Date: Monday 14 & Tuesday 15 July 2025

PRIVATE PLAN CHANGE 107 HEARING REPORT WHENUAPAI BUSINESS PARK NEIL CONSTRUCTION

Figure 13 Infrastructure Staging Plan (Source: Appendix H to the Plan Change Request)

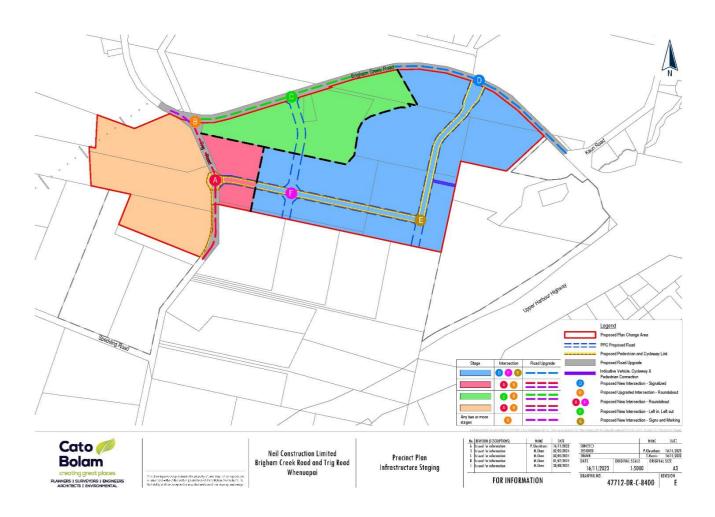
- 297. Ms Dorofaeff and Mr Shepherd do not consider that including a fourth leg from intersection 'A' in the precinct plan and the infrastructure staging plan (refer Figure 13 above) to provide access to the west side of Trig Road as sought in **[5.13]** is required if the access restrictions on Trig Road discussed above are amended. I note that inclusion of a fourth leg to intersection 'A' would not eliminate the basis for protection of Trig Road as a future arterial. Ms Dorofaeff and Mr Shepherd note the inclusion of a fourth leg access from intersection 'A' may not be the most appropriate location at which to provide access to the western portion of the PPC 107. The Auckland Council submission is not supported by a transport assessment which assesses the effects of providing a fourth leg to intersection 'A'.

Figure 2: Whenuapai Airbase Aircraft Noise Overlay on Proposed Business Park Area

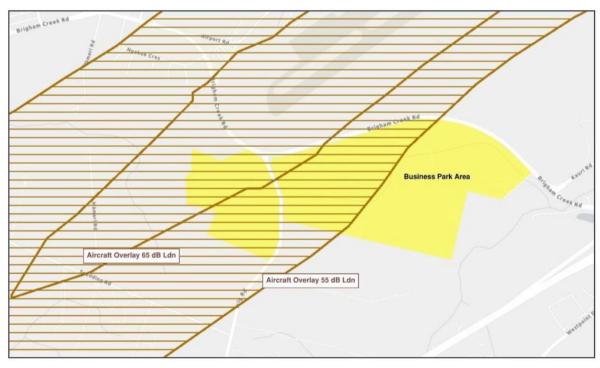
Figure 2 of the acoustic assessment identifies that the western half of the site is subject to the Whenuapai Airbase Aircraft Noise Overlay (AUP Activity Table D24.4.1 and Standard D24.6.1) – reproduced on **Figure 1** below.

Figure 7. Pre development of flood extent from flood modelling with 3.8 degree climate change in a 1% AEP storm event , source the proposed SMP, 22 October 2024

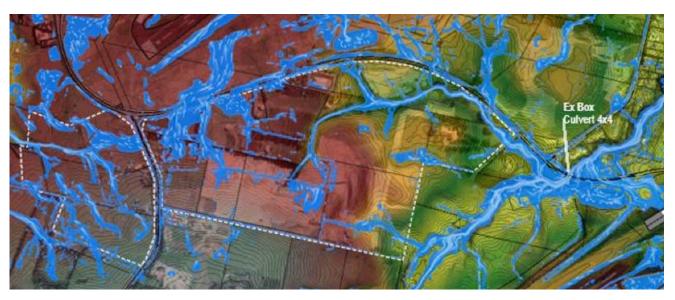
- 4.20 Flood modelling was carried out for the 1%, 10% and 50% AEP storm events with MPD of 90% impervious area and 3.8 degree climate change to assess flood effects on downstream environment and properties. The flood modelling assessment shows that the flood extent from the future development of the PPC 107 area, area generally contained within the stream channel or riparian margin, See Figure 7 and Figure 8. No habitable floor levels are affected in the 1% AEP storm event as a result of the future development in the PPC 107 area. The PPC 107 area is located in the lower half of the catchment. Excluding the increase in stormwater runoff in the stream in PCA1, the flooding effects in the PPC 107 area can be managed by earthworks, new roads and building platforms. Overall, the difference in flood extent between pre development and post development is not significant therefore no mitigation is proposed for the 1% AEP storm event for the additional stormwater runoff generated from the future development in the PPC 107 area.

Figure 15. Existing development and no climate change in a 1% AEP storm event, source Auckland Council catchment model, January 2025

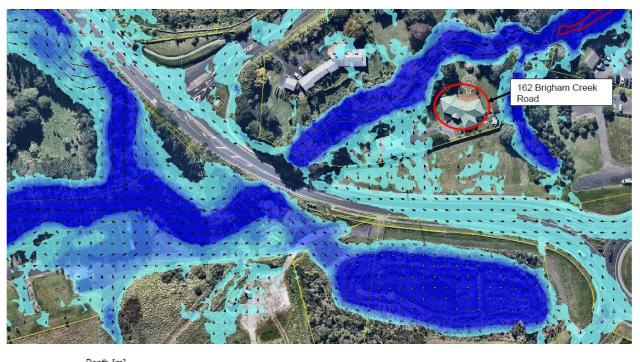
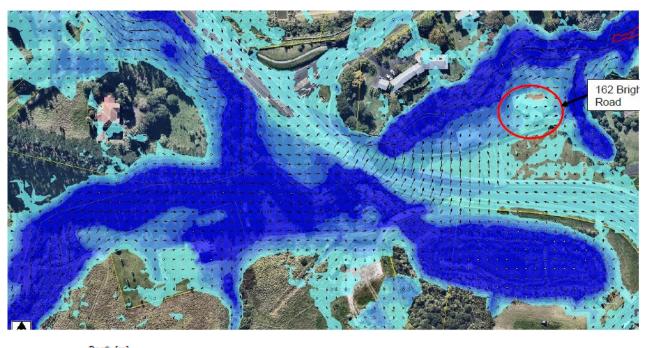
5.12 The cumulative effects can be seen in the flood modelling, see Figure 15 and Figure 16. Figure 16 shows the modelled flood extents for a 1% AEP for MPD of 80% impervious area with 3.8 degree of climate change scenario. Figure 15 shows the modelled flood extents for 1% AEP storm event for Existing Development (ED) no climate change scenario. Figure 16 shows that there is a cumulative effect downstream if there are unmitigated flows from the upstream development within the catchment, including the proposed development of the PPC 107 area. When comparing Figure 15 and Figure 16, the diagram shows increases in flood extent (increase in areas subject to a flood plain with more areas shaded in blue), flood depth (increase in shade of blue, darker blue shades is for depth of 1m or more), flood velocity (arrows show direction of flow, longer arrows is faster flow), this changes the flood hazard classification for that area. Figure 16, shows as the applicant has stated that the flood extent from the future development of the PPC 107 area, is generally contained within the stream channel or riparian margin, however, the extent of the effects including from the development of the PPC 107 also affect private properties and infrastructure, Brigham Creek Road and Watercare Whenuapai Transmission Pump Station. Figure 17 shows the effects of 3.8 degree climate change on the downstream environment with existing levels of imperviousness, it is noted that both climate change and post development with MPD of 80% impervious area result in downstream effects on private properties and infrastructure, Brigham Creek Road and Watercare Whenuapai Transmission Pump Station.

Figure 19. The driveway of 159 Brigham Creek Road (red dot), the streams, flood plains, and box culvert (purple line), source Auckland Council GeoMaps, March 2025

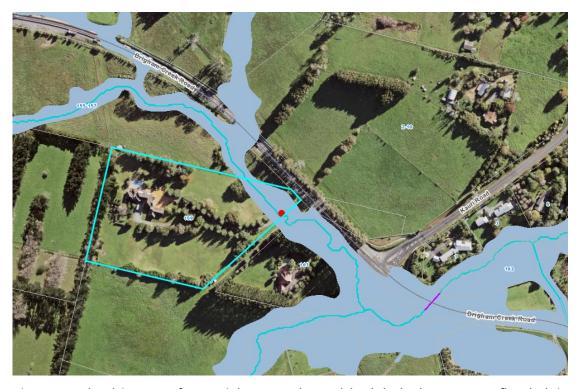
50mm. It is noted that the owner of 159 Brigham Creek Road has been consulted and stated that he has not experienced flooding on the driveway (HW 7, 23 July 2024). However, this effect will be mitigated by providing a new accessway from the proposed Road 1. It is unclear when or how this new accessway will be provided, as it is not discussed in the proposed SMP or identified in the proposed Whenuapai Business Park Precinct provisions. A recommendation has been made to the Whenuapai Business Park Precinct in the Stormwater Management standard regarding this, see Paragraph 8.4.
